301-303 BUCKLAND ROAD- CLAUSE 23 RESPONSE

Further to your recent instructions, we have reviewed the evaluation of additional transport information from Auckland Council (via Arrive) and have responded. The items below only relate to the items noted as requiring additional information.

Figure 1: 15 minute travel time

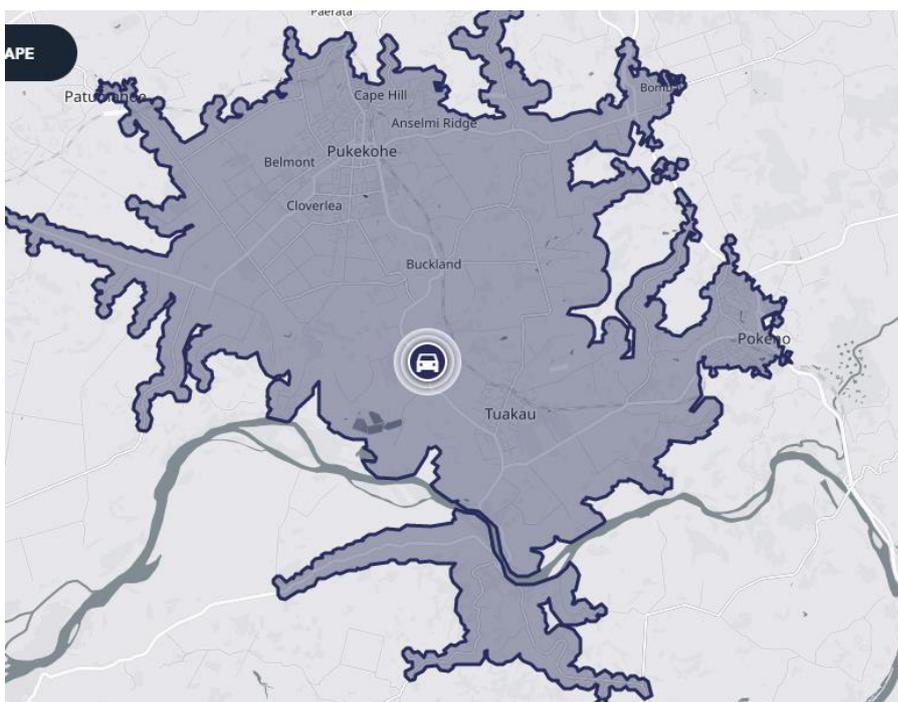
Most population growth is expected to the north of the site, so the north is likely to represent an increasing proportion of trips in future.

Insufficient information has been provided to support the assumed north/ south splits.

We note the comment that the north is likely to represent an increasing proportion of trips in future. In this regard we have reviewed the existing and future population in the wider area. In this regard the map below shows the site and the estimated 15-minute travel time from the site.

Of note within 15 minutes travel time is Pukekohe, Tuakau and Pokeno.

As such Tuakau and Pokeno currently represents 28% of total population in 15 driving distance of the site. The distribution of 30% from the south is reasonable.

As such Tuakau and Pokeno is proposed to represent 34% of total population in 15 minute driving time of the site. The distribution of 30% from the south is still considered reasonable.
